**Cub Crafters, Inc. Considers Compliance Mandatory**

**EFFECTIVE DATE:** This SERVICE BULLETIN is effective October 19, 2008

**SUBJECT:** THROTTLE CABLE ADJUSTMENT

**MODELS AFFECTED:** CC11-100 S/N CC11-00002 THRU CC11-00091.

FIGURE 1

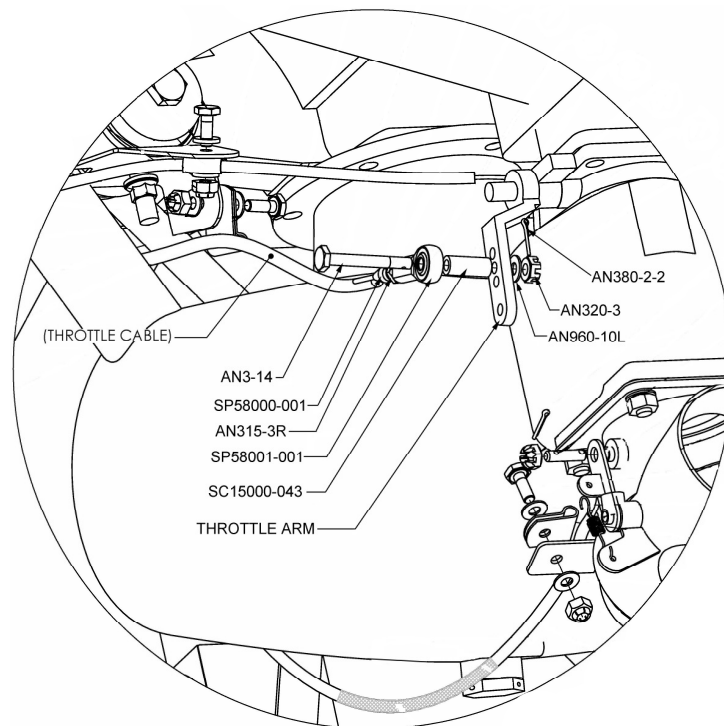
1. Remove the engine cowl.
2. Using Figure 1, loosen jam nut AN315-3R.
3. Remove AN380-2-2 cotter pin, AN320-3 nut, and AN960-10L washer.
4. Remove AN3-14 bolt and SC15000-043 spacer

8. Reassemble per Figure 1 and lightly tighten AN320-3 nut.

**FIGURE 2**

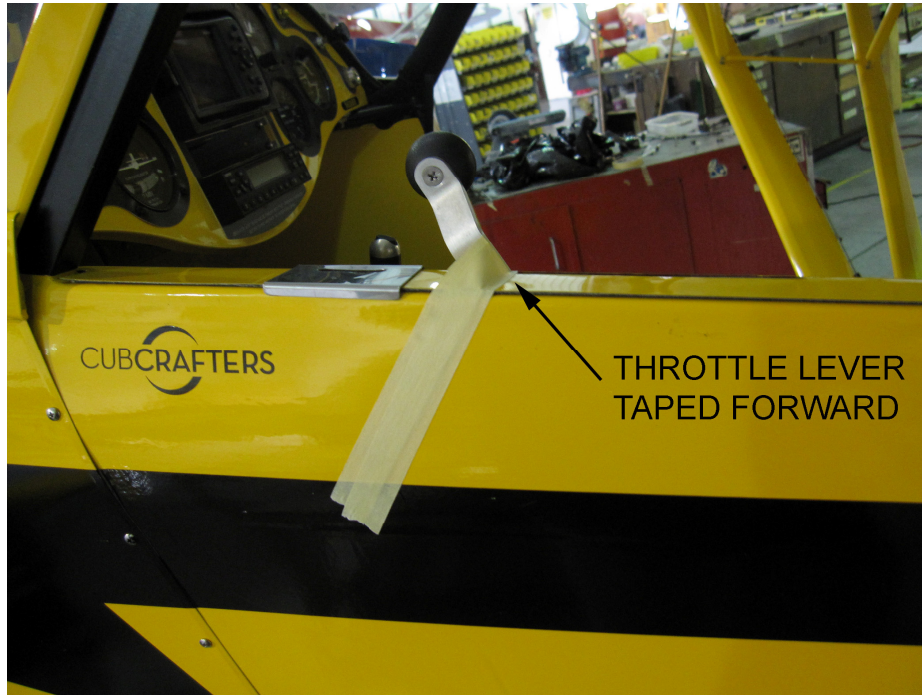
5. From the cabin, push the forward throttle full forward and secure it with masking tape as shown in Figure 2.

**FIGURE 3**

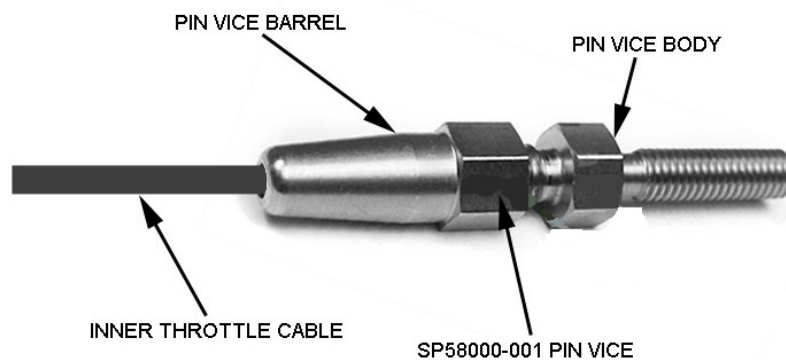
6. From the engine, push the throttle arm fully forward.
7. Turn the ball end of the pin vice (SP58001-001, see Figure 3) in or out to adjust it, so the ball end “eye” lines up with the hole in the throttle arm from which it was removed.

**FIGURE 4**

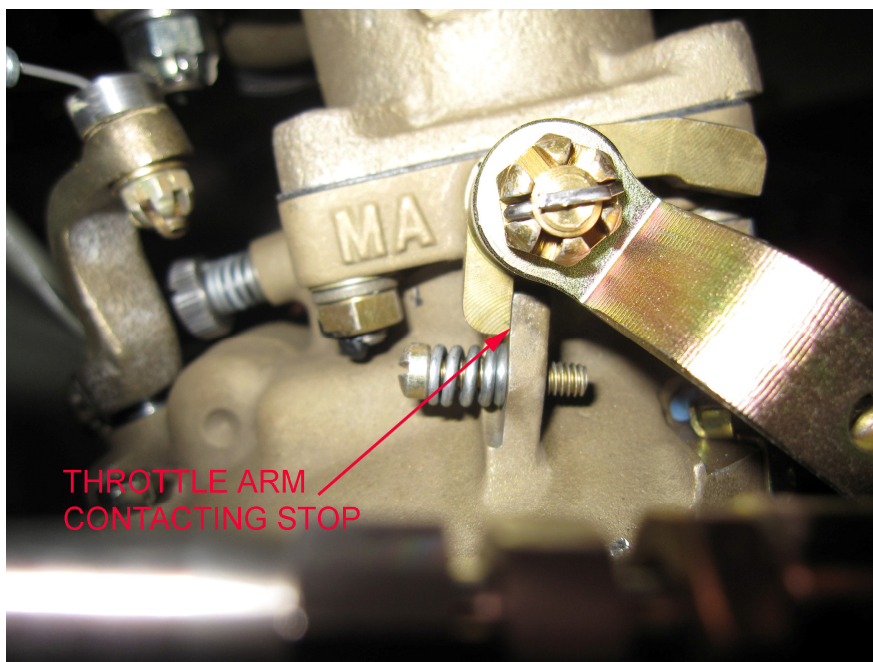
9. Recheck for cable buffer and readjust, if necessary.
10. If the cable buffer has been removed, check the throttle arm to ensure it touches the stop on the carburetor when the forward throttle in the cabin is full forward as shown in Figure 4.

11. If the throttle arm stop does not touch the carburetor when the forward throttle in the cabin is full forward, readjust as necessary.
12. If the throttle cable has no buffer and the throttle arm touches the carburetor in the full forward position, the throttle has been adjusted correctly.
